**Re: 11ITB79954K-JAJ**  
**Fire Station # 11 Construction Services**

**11ITB79954K-JAJ**  
**Fire Station # 11 Construction Services**  
**Addendum No. 5**  
**Page Two**

**Fulton County Fire Station No. 11**  
**Addendum No. 5**

**FRONT ELEVATION**  
1/8" = 1'-0"

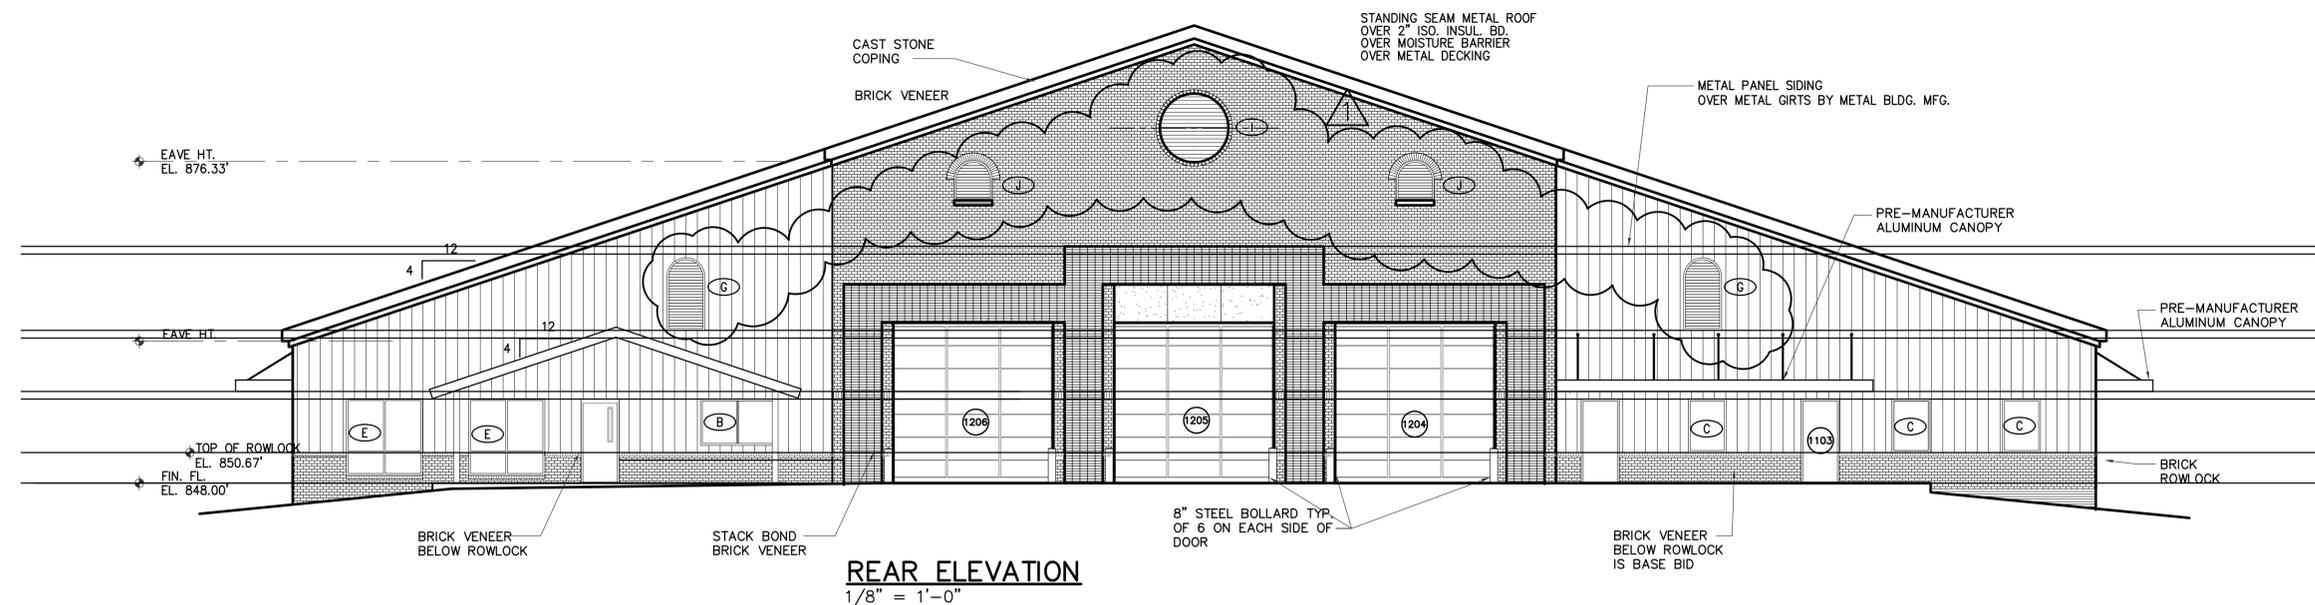
Answer: the Apparatus Bay walls are 12" CMU as noted in Addenda #2.
10. Question: Exterior Elevations A5.1 Front, Window numeration does not match window schedule. Clarify

18. Question: Drawings A5.1 Front elevation in the Circular precast then is a number "11". Is this part of the precast or is this bronze lettering? Is this provided by owner? If provide by contractor, provide details and specifications.

Answer: See revised A5.1 attached.
11. Question: Exterior Elevation A5.2 left side window numeration does not match the floor on A2.1 window numeration. Please clarify.

Answer: See dimensioned profile on sheet A5.1 for the coping.
15. Question: Provide finished floor elevations for the trench drains on sloping as noted in Addenda 32 item #5.

Answer: this is cast stone provided by the contractor. The numbers are relief into the cast stone.
19. Question: Specification 10140-2.6 References a Bronze Plaque. Provide Text of plaque for pricing. The amount of text determines the price.

SHEET 35 OF 69  
DWG NO. **A10.1**  
DATE JULY 15, 2011  
PROJ NO. 10ATL02-55

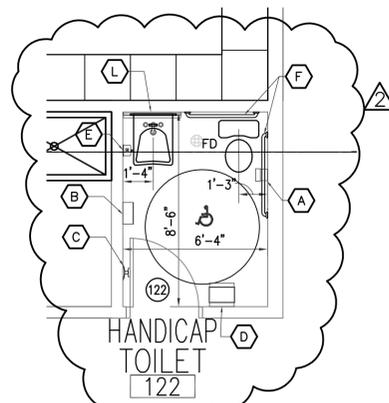
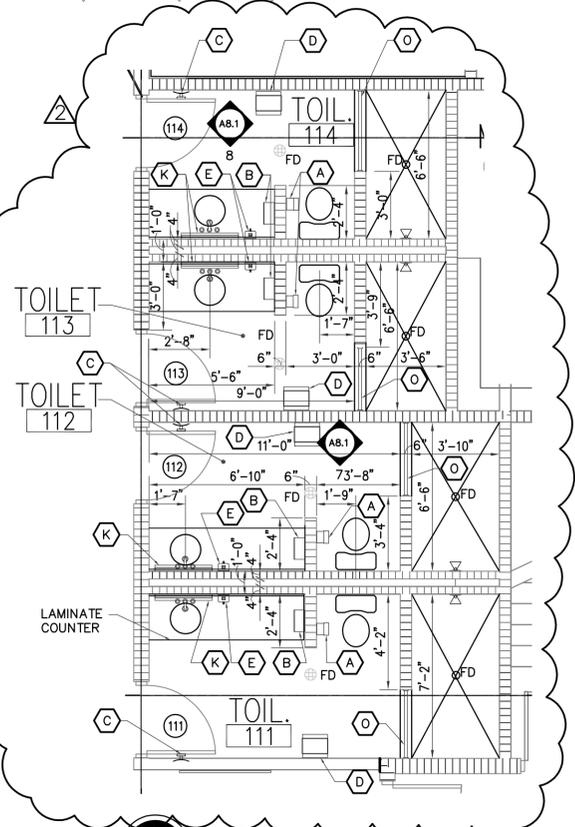
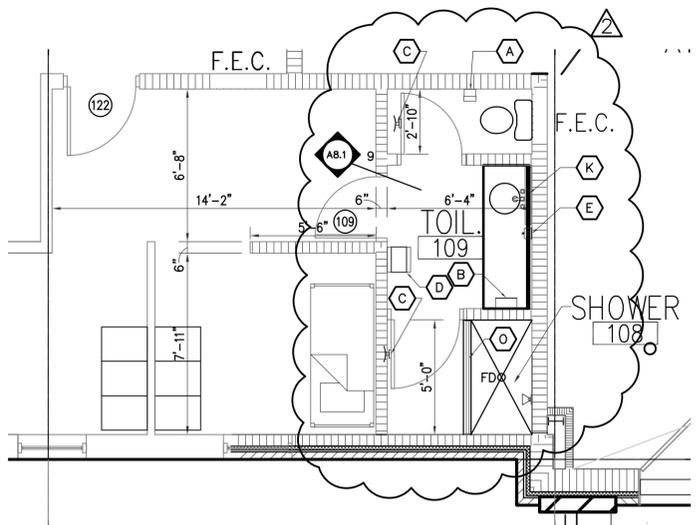
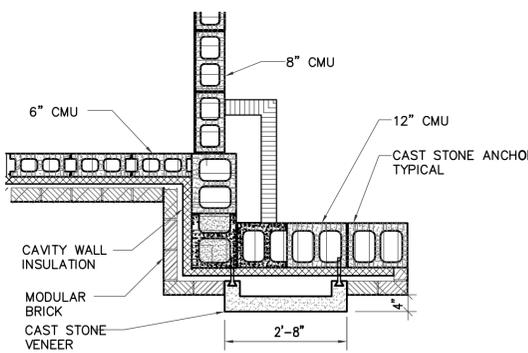
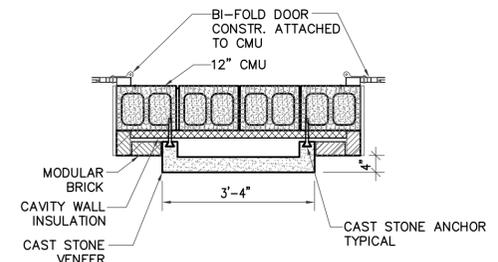
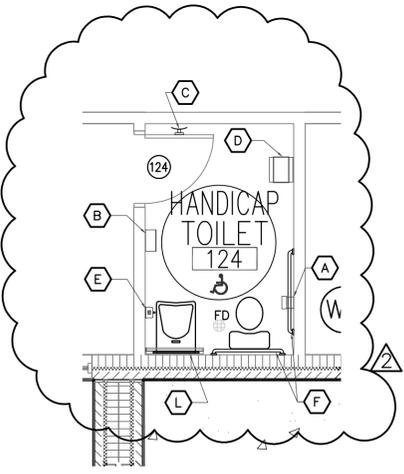
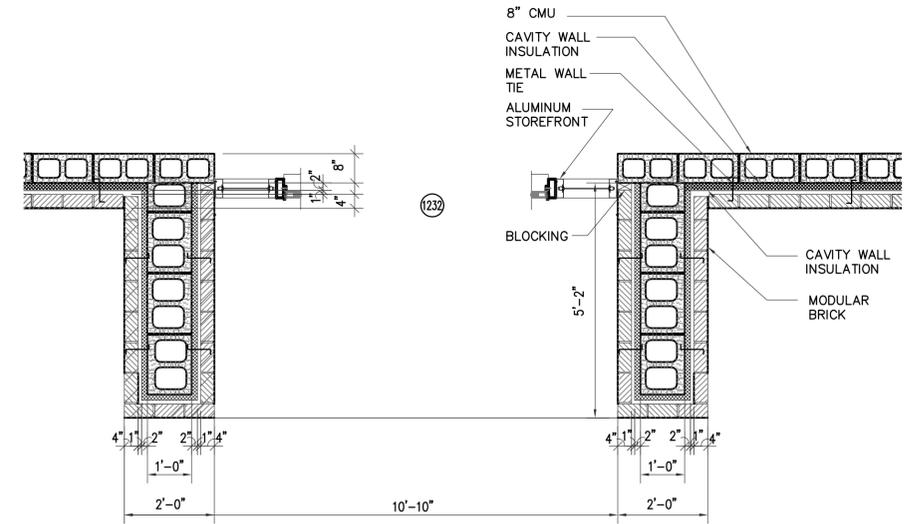
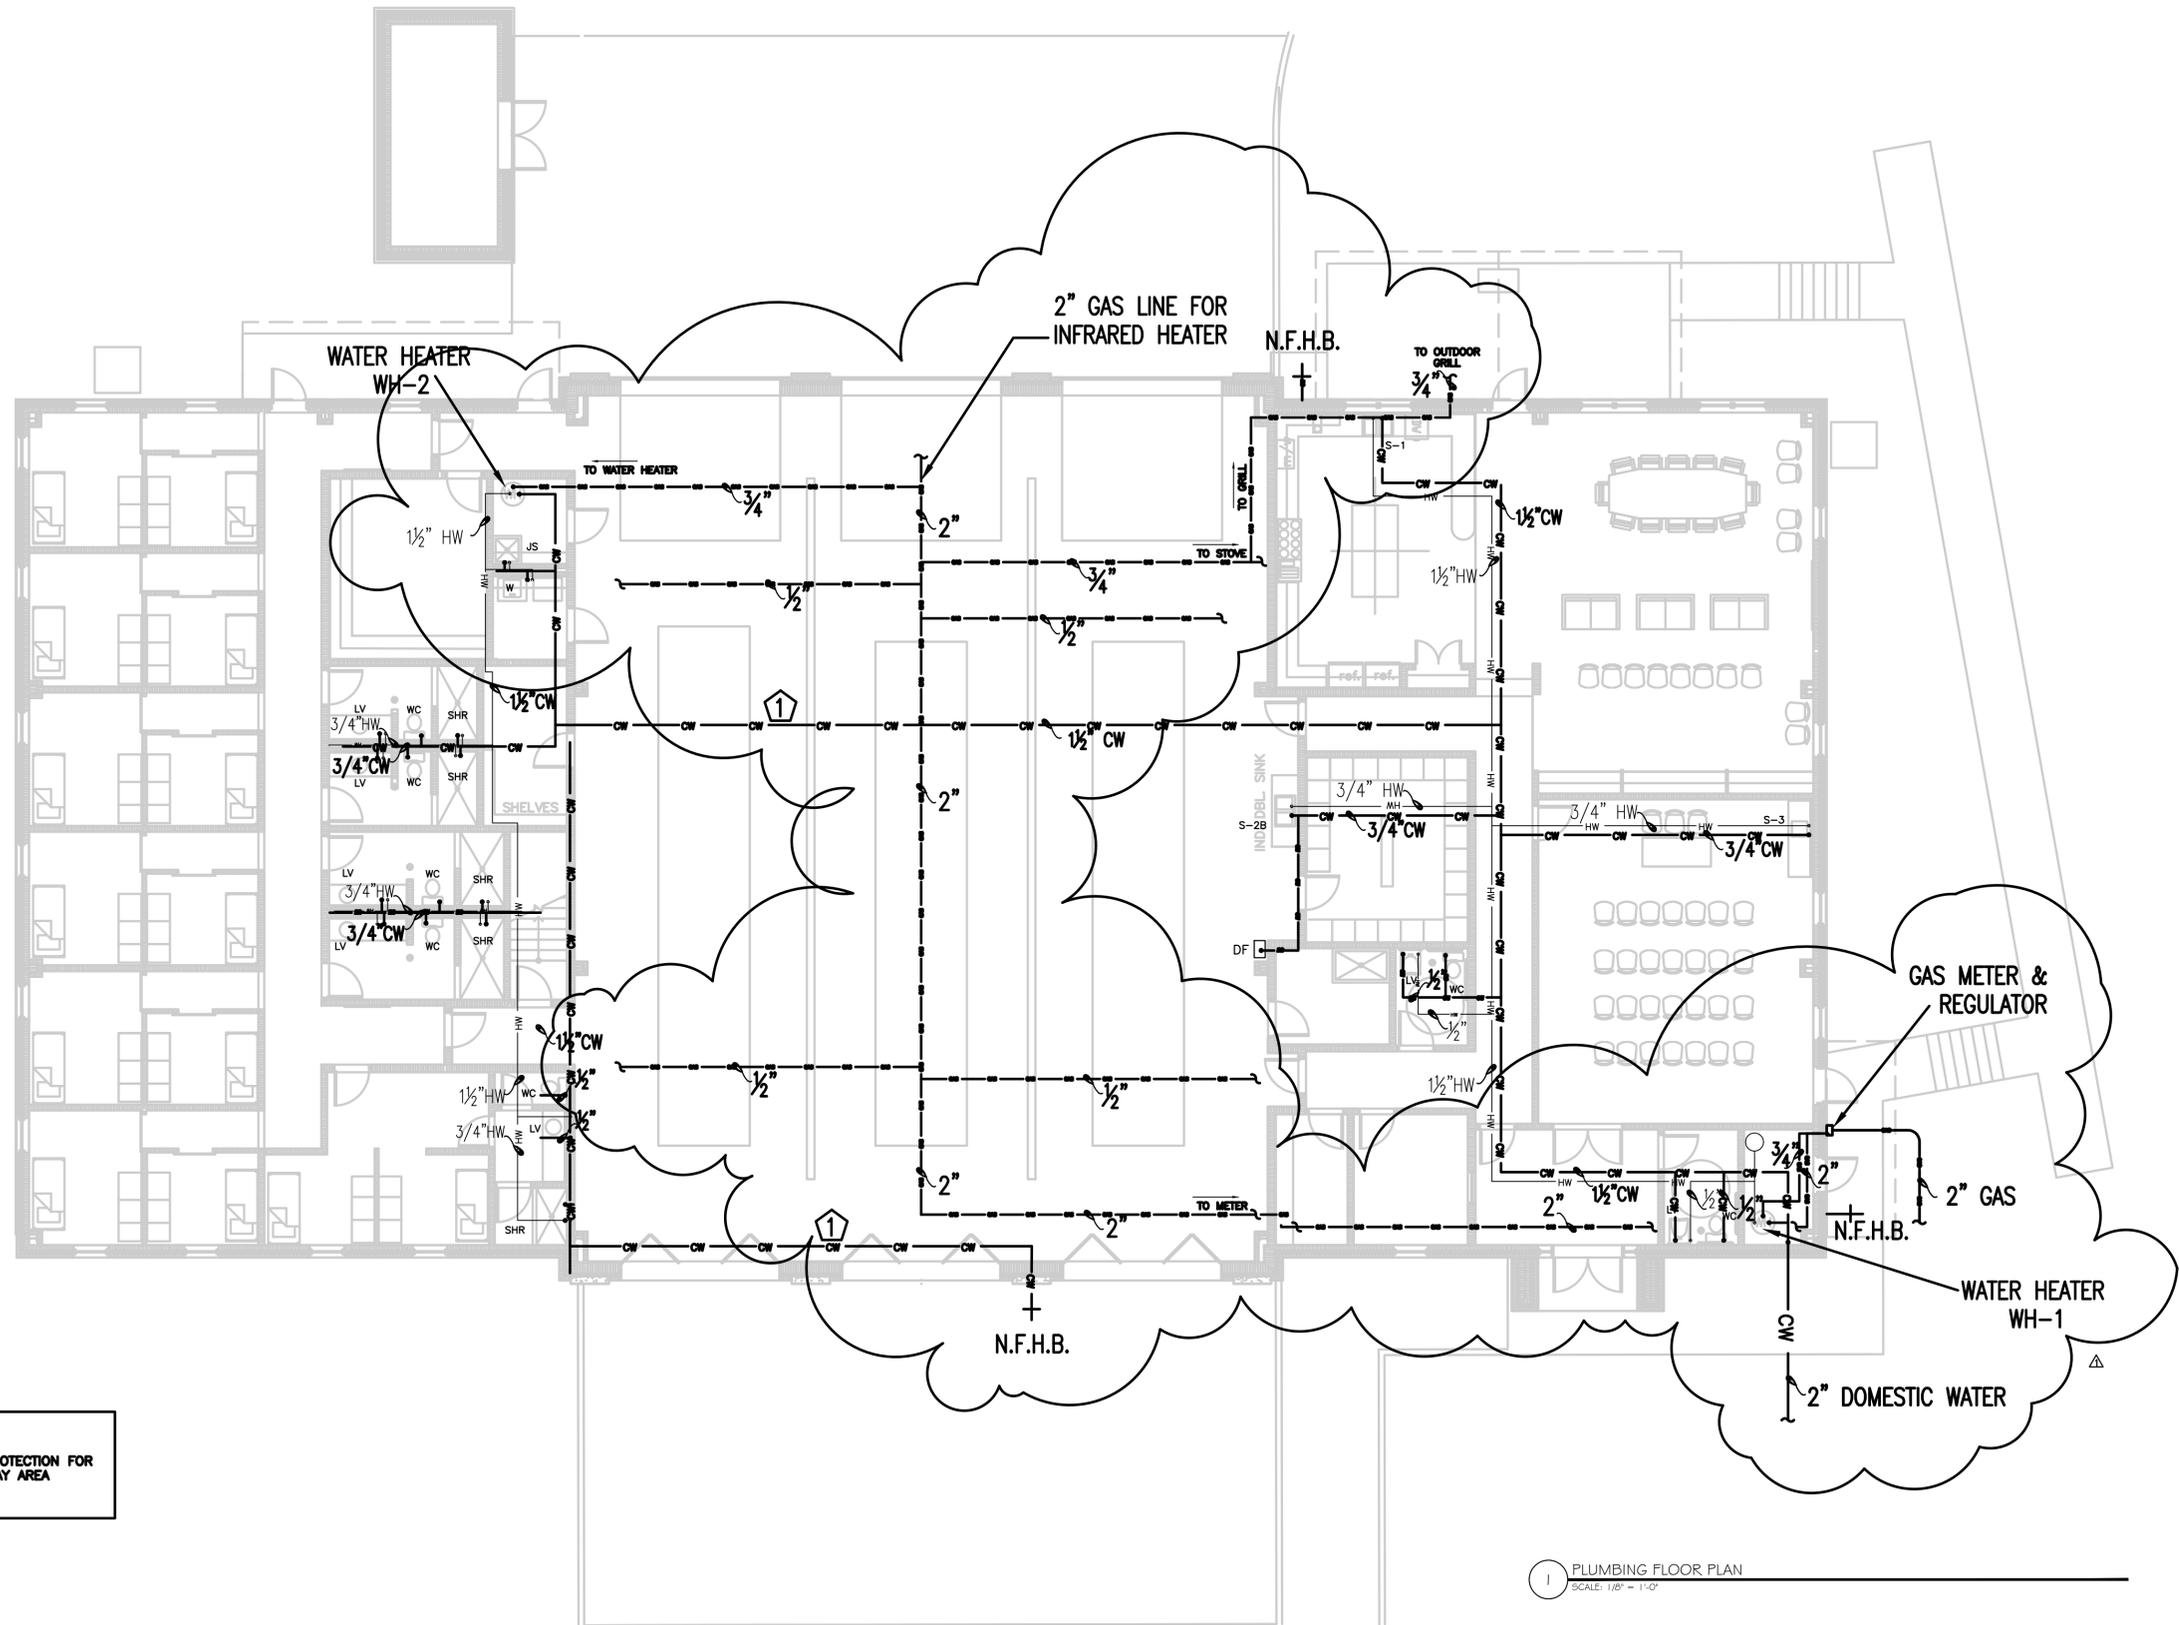
21. Question: Specification 10280 "Toilet and Bath Accessories" 2.2.D list it as item "C" Paper Towel dispenser (Roll) While Item "C" on the Toilet accessory Schedule list Item "C" as Hat and coat Hook on the Revised Drawings Addenda #2. Please clarify also if it is a hat and coat hook, provide missing specifications.

Answer: See revised section 10280 Toilet and Bath Accessories and revised sheet A10.1 for correct items.
22. Question: Drawing 11/A8.1 Toilet 124Toilet Accessory Schedule Mark does not match. Provide correct identification of accessories.

Answer: see revised sheet A10.1.
23. Question: The following Toilet Accessory Schedule Mark Symbols are not shown on the drawings but are listed in the schedule on the drawings: Type "G, J, L, M & N", provide locations.

Answer: delete items G, J, N, & N. Item M is to be located in the Janitor's closet. Item L is located in the Handicapped Toilets.
24. Question: Drawing 3/A10.2 has detail for kitchen listed for sheet A4.5. Drawing is not included in documents, provide missing drawing and elevations.

SHEET 54 OF 69  
 DWG NO. **P.01**  
 DATE JULY 15, 2011  
 PROJ NO. 10ATL02-55

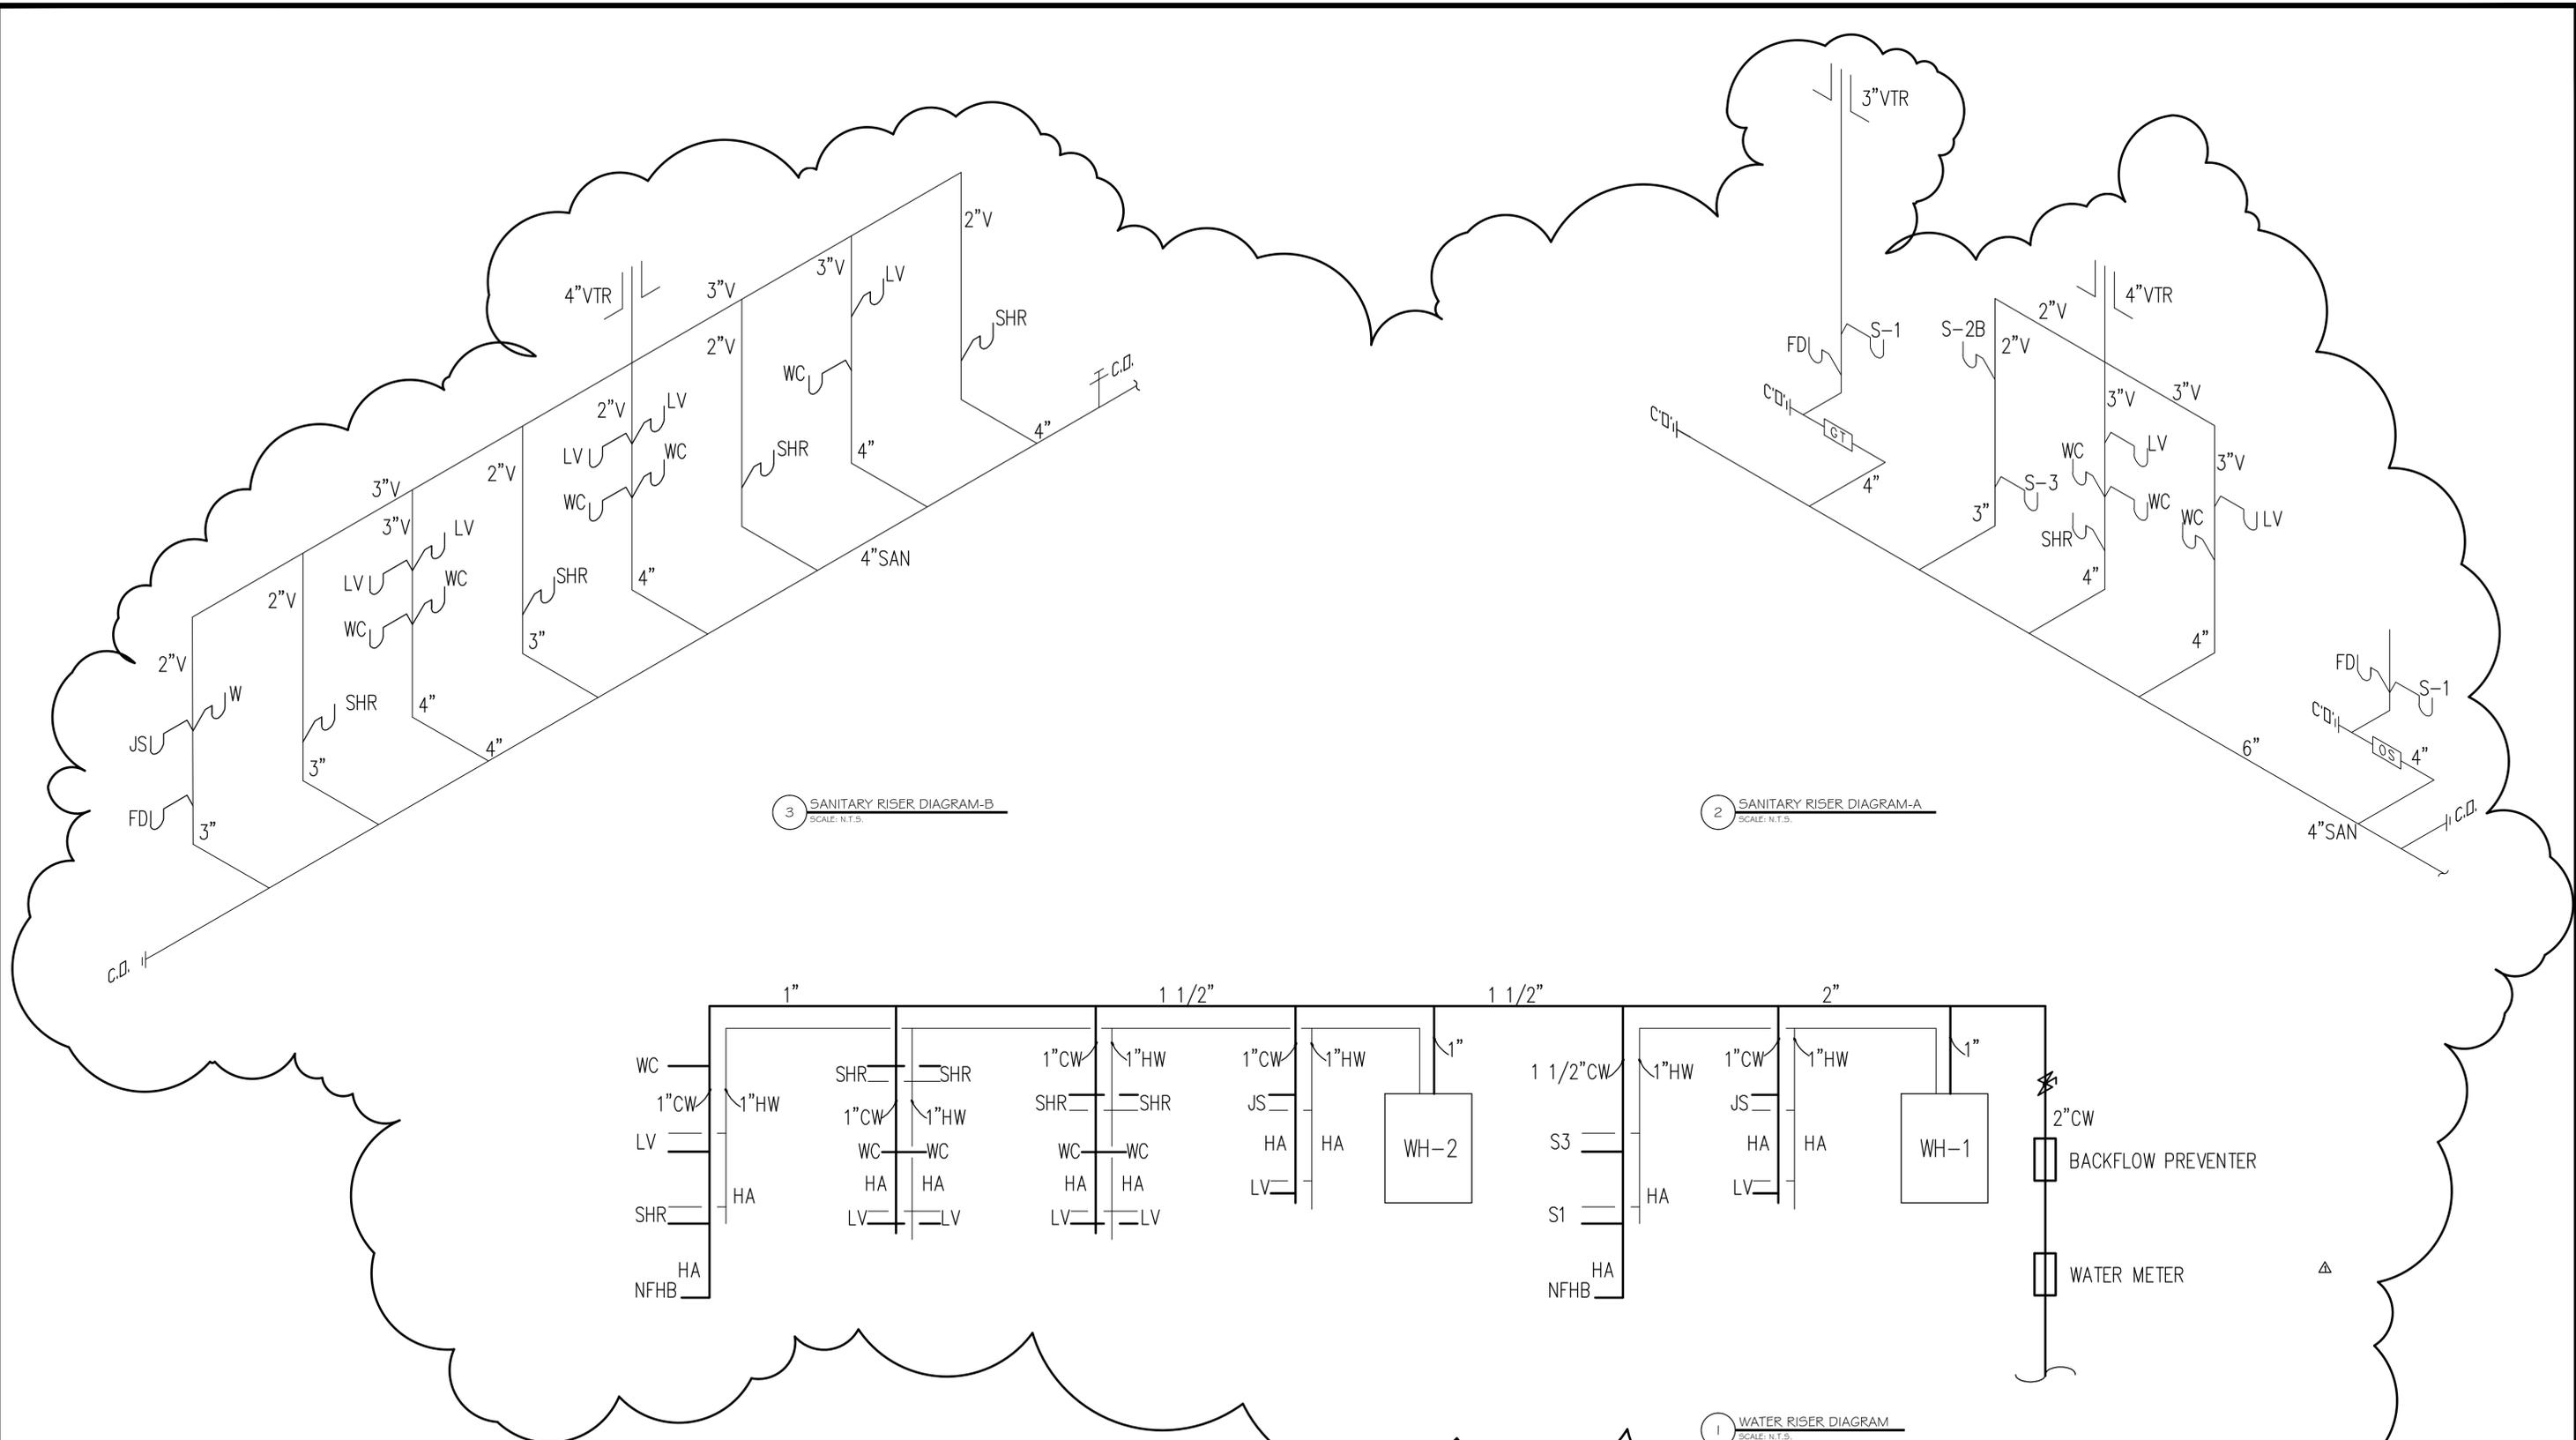
29. Question: Drawing P.01 provide specification for fixtures DF & S-2R, these are not indicated on the fixture schedule.  
Answer: Delete DF (drinking fountain, non shown on Arch plans). S-2R is shown on the schedule as S2B.
